14-15. LINK BETWEEN WRE/TSF MANAGEMENT AND GROUNDWATER ASSESSMENT

Figure 1: Structural geology – adapted from Figure 11 of (Jacobs (Australia), 2020, pp. 5-57)

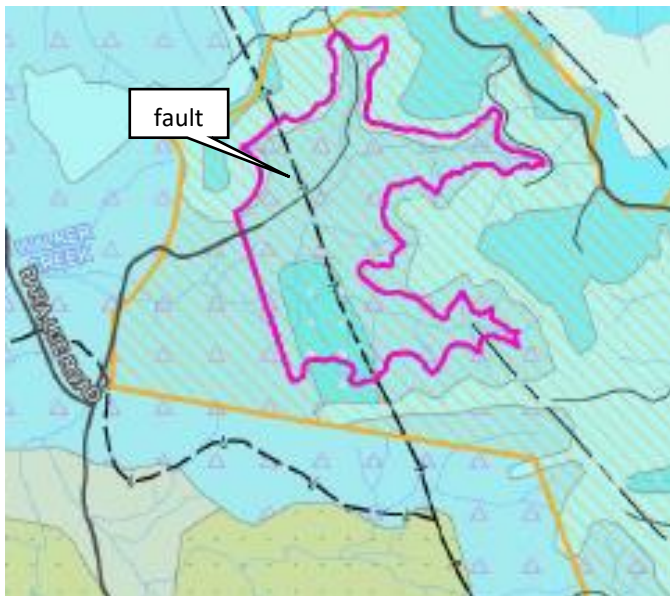
One example of the need for higher resolution (fine grid) models is the disconnect between the Jacobs (2020) work and the Cardno (2020) and ATC Williams (2020) work when faults are considered. Faults have the potential to readily transmit large quantities of groundwater. The only reference to the faults mapped beneath the planned TSF is on page 2 of ATC Williams (2020). ATC Williams (2020 p.2) suggest leakage through faults (Figure 1) is considered in 'Section 7'. Transmissive faults can form a highly transmissive underground flow conduit in a preferred direction, potentially to a significant receptor. No reference to faults can be seen in Section 7 and the TSF design and monitoring plan in ATC Williams (2020) does not appear to consider the leakage risk posed by faulting (ATC Williams, 2020).

Figure 2: West-east modelled cross section. Source: Adapted from Figure 51 from (Jacobs (Australia), 2020, pp. 5-143)

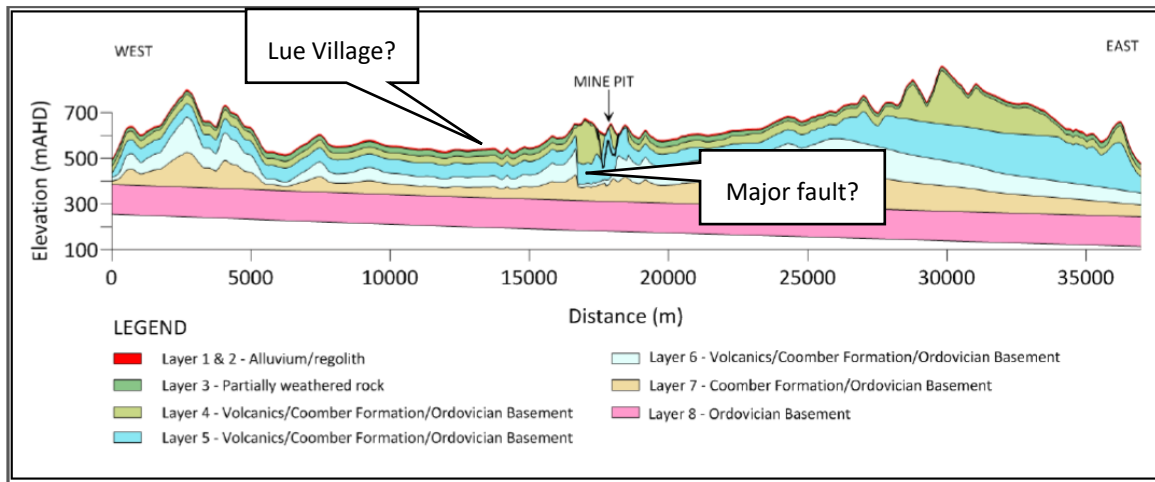
Similarly, the leachate management dam and sumps designed to capture leachate from the ~22 million tonnes of potentially acid forming (PAF) waste rock do not consider the presence of faults. Figure 2 indicates that the throw on this fault may be hundreds of metres.

Figure 3: relative elevation of TSF and Lue Public School. Source: Figure 4.9.2 of (R. W. Corkery & Co. Pty. Limited, 2020, pp. 4-210)

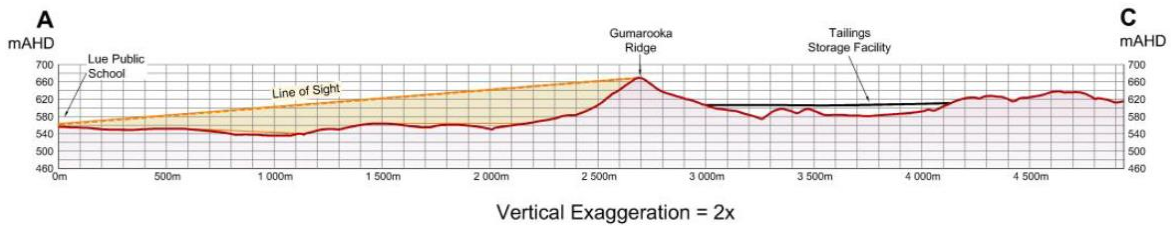
Many beneficial uses of groundwater occur near the township of Lue, however, there is no hydrostratigraphic section, nor cross section, between the proposed mine and Lue to indicate the pathway linking the proposed activity to the Beneficial Uses. Figure 3 shows that the elevation of the TSF (600-615 mAHD) is higher than the Lue Public School (~560 mAHD). No groundwater contour map or particle tracking map >100 years post mining is presented in the EIS to infer groundwater flow direction.

Figure 4: Pit lake equilibrium - between 573-578 mAHD. Source: Figure 75 (Jacobs (Australia), 2020, pp. 5-174)

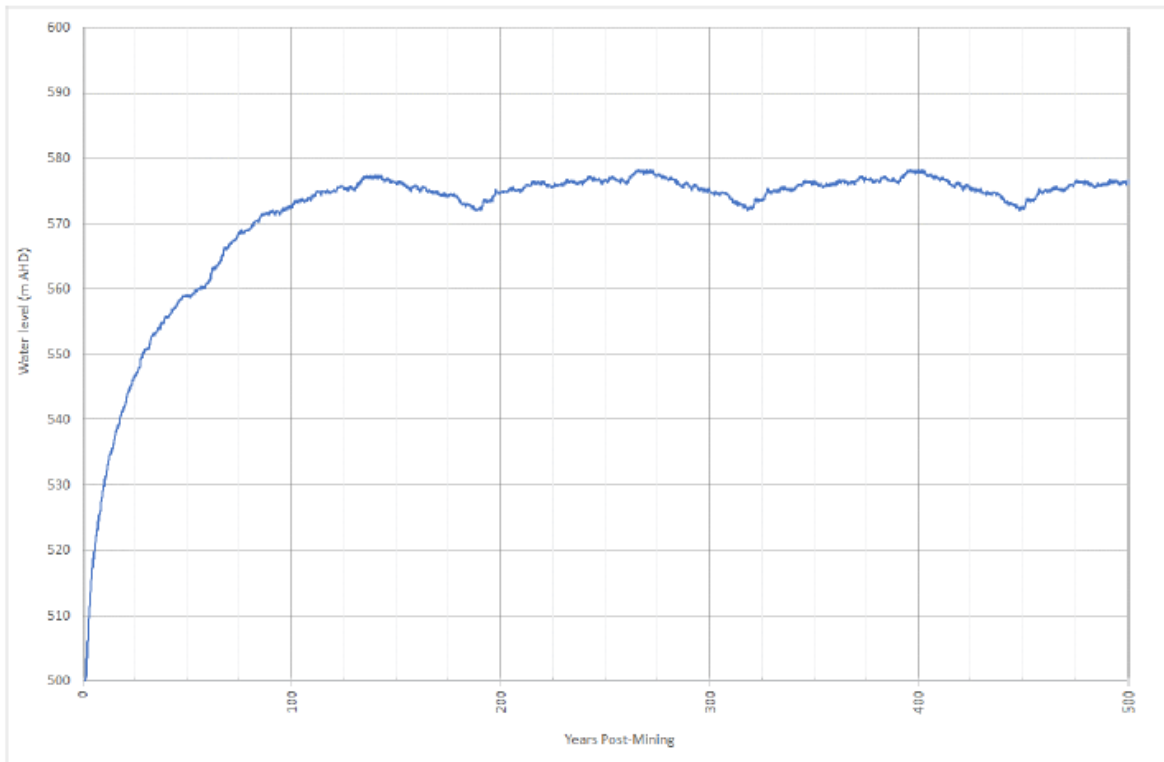
The Jacobs model also does not indicate groundwater flows when the pit lake level stabilises (50-300 years after the proposed activity commences). Figure 74 of Jacobs (2020) shows the drawdown after 50 years, however, no drawdown map of 130 years is presented in the EIS. This is when the pit lake level is predicted to equalise at 573-578 m (depending on the decade - refer to Figure 75), around 30 m higher than the 543-548 mAHD groundwater levels around the Lue village shown in Figure 25b (Jacobs (Australia), 2020, pp. 5-91). Evaporation is predicted to lower the water level by 5 m from pre-mining levels. An updated groundwater contour map is likely to demonstrate the inferred flow direction of leachate away from as well as towards the equalised pit lake level.

An appropriate resolution groundwater contour map post mining, 50 years post mining and 130 years post mining would help confirm the groundwater flow gradients around the pit lake and beneath other key site infrastructure such as the TSF and leachate management dam. Particle tracking using the groundwater flow model or a solute transport model would also confirm that potential seepage from the TSF and WRE reports to the pit lake.
